PINS Ref No: APP/G5180/W/25/3365514

### **PROOF OF EVIDENCE OF NOJAN RASTANI**

**LBB Reference: C/24/00815/FULL2**

**Address: Land at London Electricity Board Depot, Churchfields Road,  
Beckenham, BR3 4QZ**

Swept Path Analysis Recycling Centre Entrance Scaffold Truck (10m Rigid)  
produced by SLR drawing no. 237324/AT/B01 dated 21 February 2024

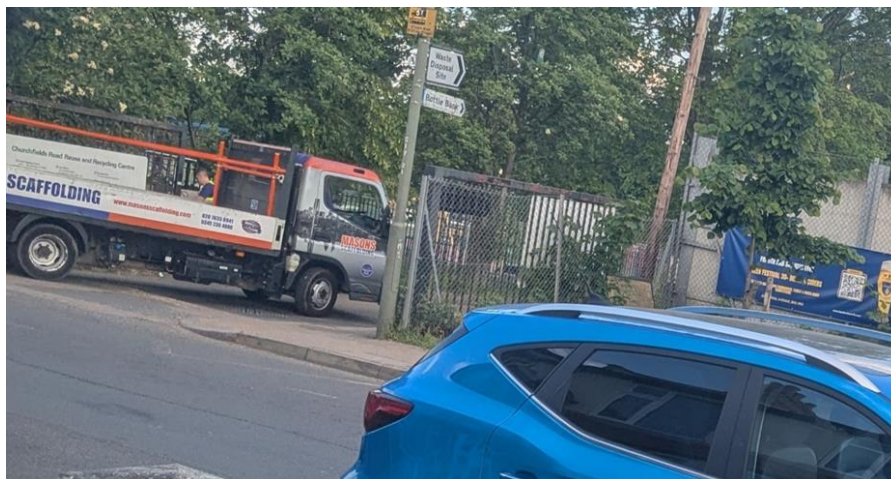
6.5 The SLR Transport Statement, dated 21 February 2024 and included as “Enclosure 4”, illustrates that a 10-metre rigid vehicle is unable to complete turning manoeuvres into and out of the site without encroaching into the opposing carriageway. Specifically, when turning left into the site, the vehicle must cross over the centre line and utilise part of the oncoming traffic lane, thereby creating a potential conflict with vehicles approaching from the opposite direction. Similarly, when exiting the site by turning right, the vehicle again intrudes into the opposing lane, posing a risk to road safety. These movements indicate that the access arrangements are not suitable for larger vehicles and raise significant concerns regarding the safe operation of the junction under typical traffic conditions.

6.6 I supplement my concern with this photograph by a resident (taken from google drive folder) showing the swept path taken in real time taking place. The reason that the truck is swinging to the far side of the road is because the road is narrow, and the radius of the kerb doesn't allow the movement to take place in a safe manoeuvre. The constraints of the access pose significant safety concerns, particularly because pedestrians frequently cross this route, and vehicles regularly enter and leave the Recycling Centre.

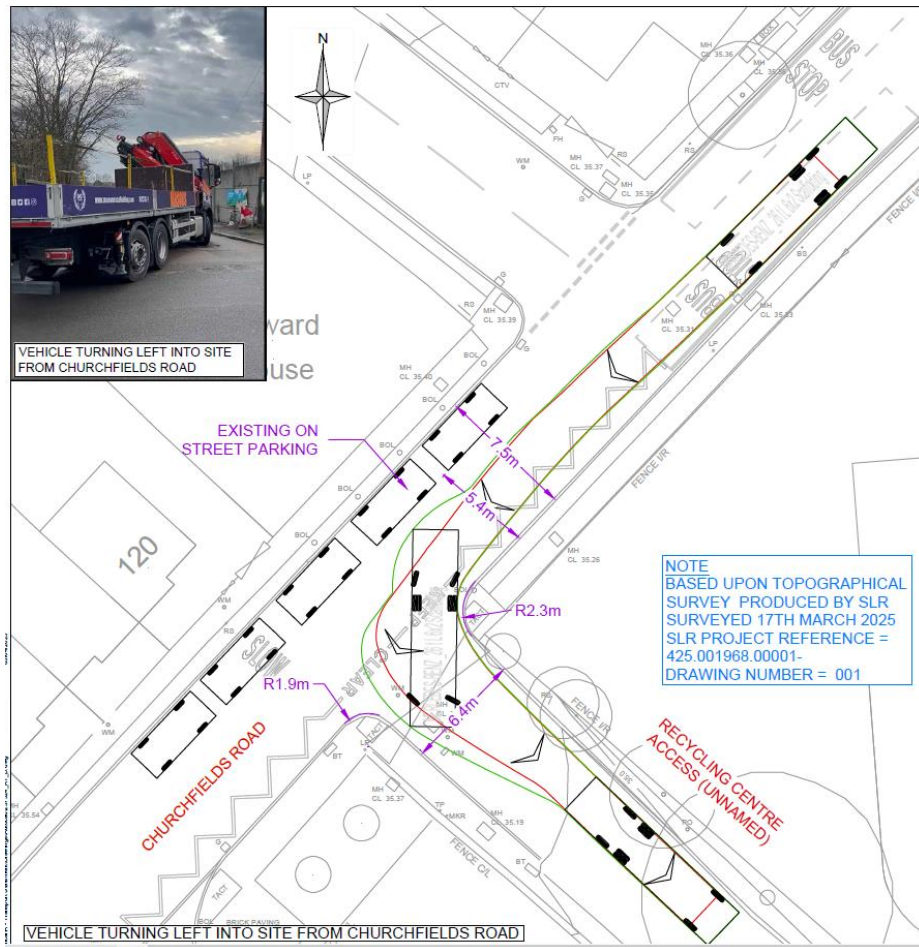
6.7 The latest swept path analysis confirms that in order to exit the access road onto Churchfields Road, an articulated vehicle must utilise the full width of the access road.

6.8 The fundamental point is the access conditions are unsafe because of the width of access road, the type of HGV turning in and out and the tight turn required. This is particularly the case because the access road is also used by pedestrians crossing the footway and by vehicles seeking entry to the Recycling Centre. The residential parking further limits the turning in and out. The existing access is not designed to accommodate the size of vehicles operated by Masons Scaffolding—whether 10-metre rigid or 16.5-metre articulated lorries. The width of the access and the tight junction radii prevent safe ingress or egress in a single movement. I include below a section of the swept path analysis showing these problem in action. There have been instances where lorries have overridden the kerb due to the limited road space, which makes it difficult to manoeuvre safely within the confines of the carriageway.
